ITB-2015-132- Addendum No. 1 - dated 3 August 2015

Pre-bid Meeting Minutes / Addendum No.1

ITB-2015-132: Extension/Expansion of Jericho Landfill Site and Construction of Materials Recovery Facility with Transfer System

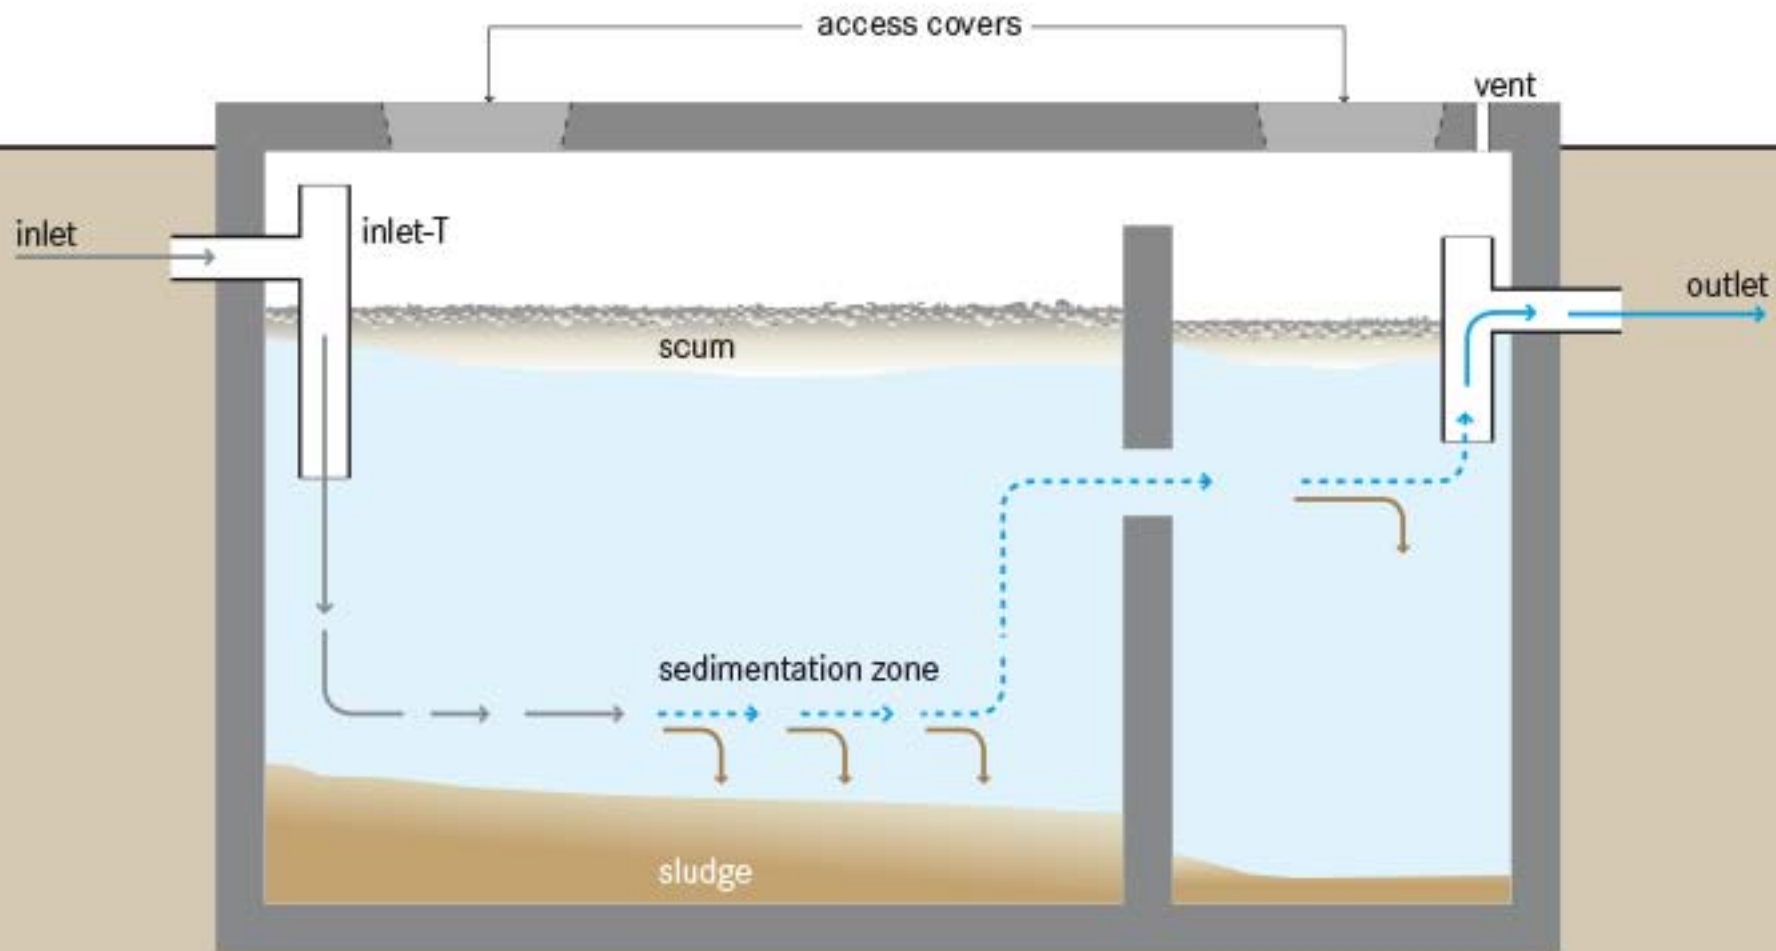
4.	Referring to Item 15.5 Please supply us with details and steel reinforcement for the septic tank.	Septic Tank scheme is as shown attached image. Attached also related reinforcement steel details. The contractor is responsible to submit final shop drawing for this item for supervisor Engineer approval
